E97-24

IBC: SECTION 202 (New), SECTION 202, 1022.1, 1022.3 (New), 1023.3.1, 1022.3.2 (New), 1022.3.2.1 (New), 1022.3.2.2 (New), 1022.3.2.3 (New), 1008.3, 1024.5; IFC: SECTION 202 (New), SECTION 202, [BE] 1022.1, 1022.3 (New), [BE] 1023.3.1, 1022.3.2 (New), 1022.3.2.1 (New), 1022.3.2.2 (New), 1022.3.2.3 (New), [BE] 1008.3, [BE] 1024.5

2024 International Building Code

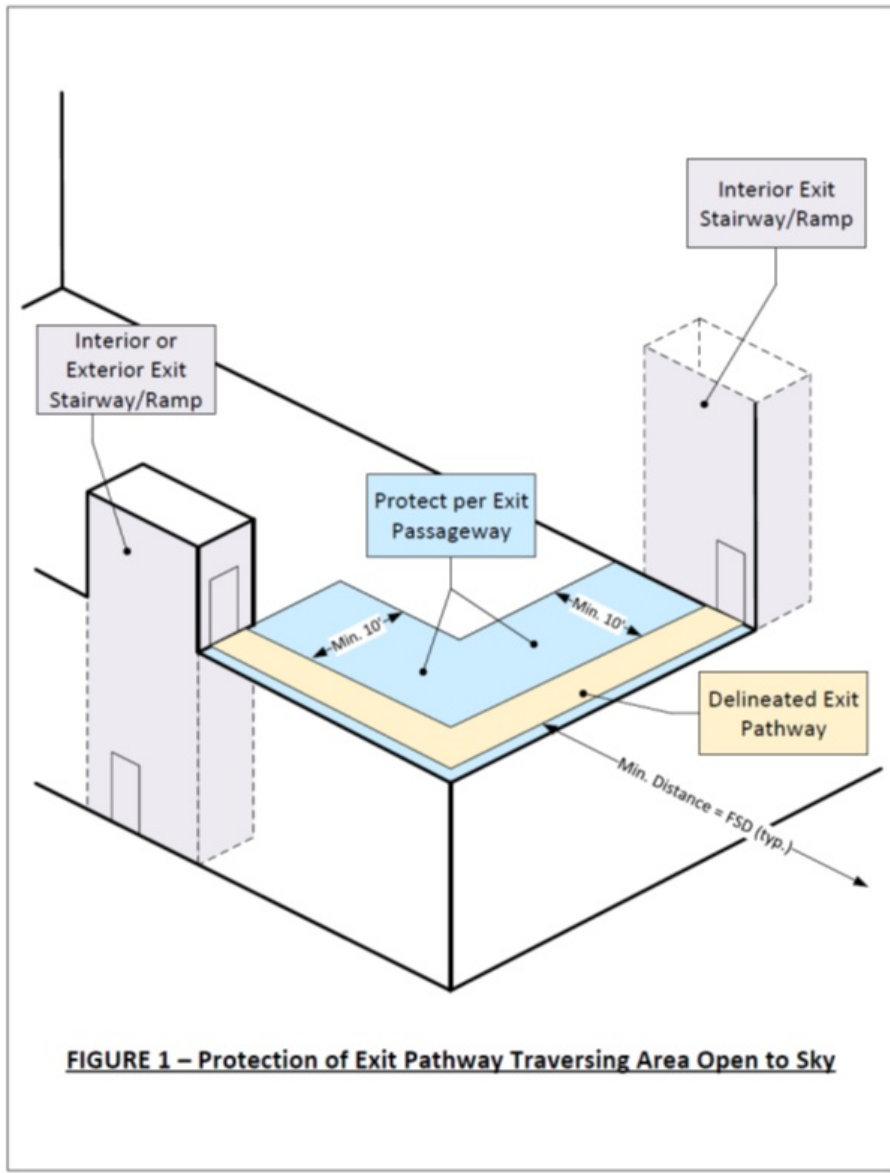
1022.3.2.1 Construction and openings: The floors and walls of the *exit pathway* would be protected like an *exit passageway*, but there would be no ceiling that needs protection. The exit pathway is protected from fires below by requiring the horizontal assembly required in 1024.3 to extend 10 feet from the edge of the pathway. Where there is a minimum of 10 feet of horizontal separation between the edge of the *exit pathway* and other parts of the building, then no walls would be required. However, where *building* walls are less than 10 feet from the edge of *exit pathway*, they must be protected for a vertical distance of 10 feet (see Figure 2 below).

1022.3.2.1 Construction and openings. The floor, walls, and openings of the exit pathway shall be constructed in accordance with Section 1024 for exit passageways for a minimum horizontal distance of 10 feet from the edges of exit pathway and a minimum vertical distance of 10 feet from the floor of the exit pathway.

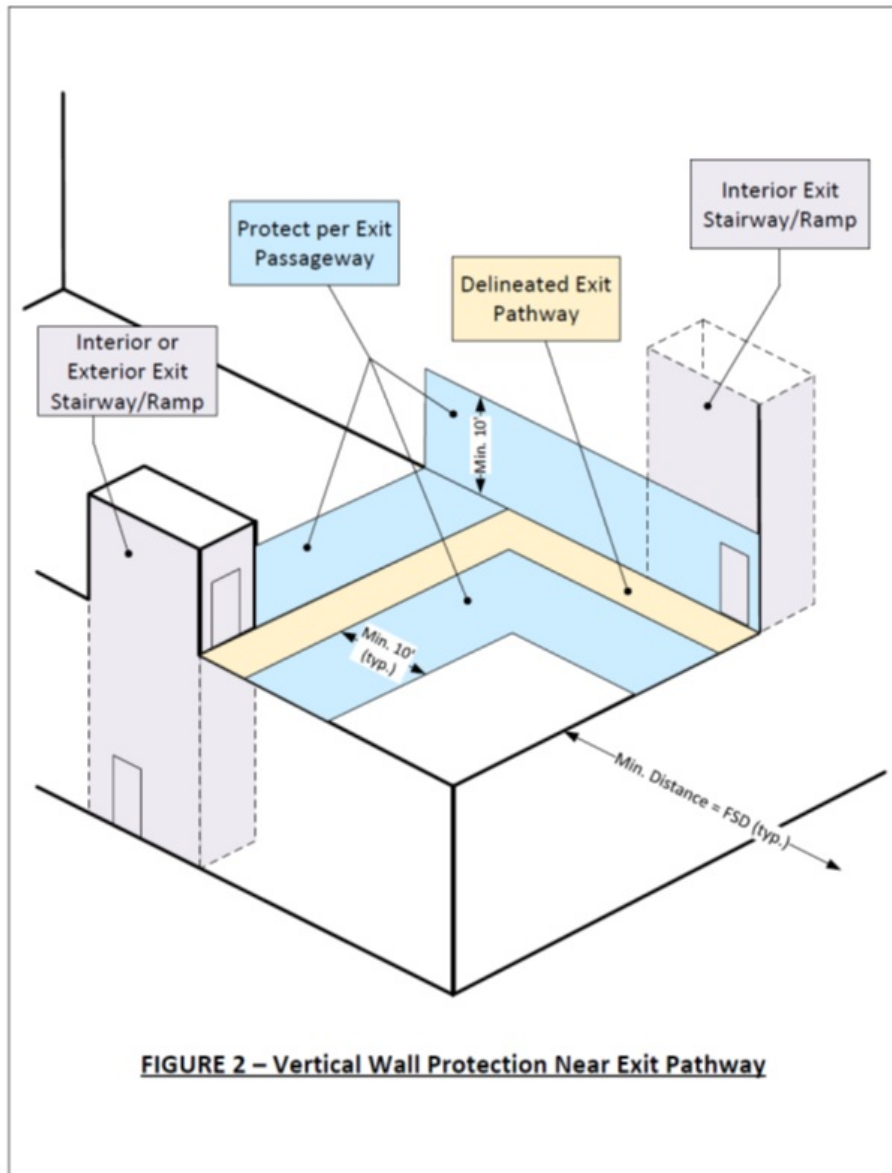
1022.3.2.2 Location: The hazard of adjacent buildings is mitigated with a requirement to have 10 feet of *fire separation distance* between the edge of the *exit pathway* and the lot line, centerline of the right-of-way, or an imaginary lot line, which is similar to how Section 1027.5 protects exterior stairs.

1022.3.2.2 Location. The exit pathway shall have a minimum fire separation distance of 10 feet (3048 mm) measured at right angles from the exterior edge of the exit pathway, to:

1. The closest interior lot line.
2. The centerline of a street, an alley, or public way.
3. An imaginary line between two buildings on the lot.
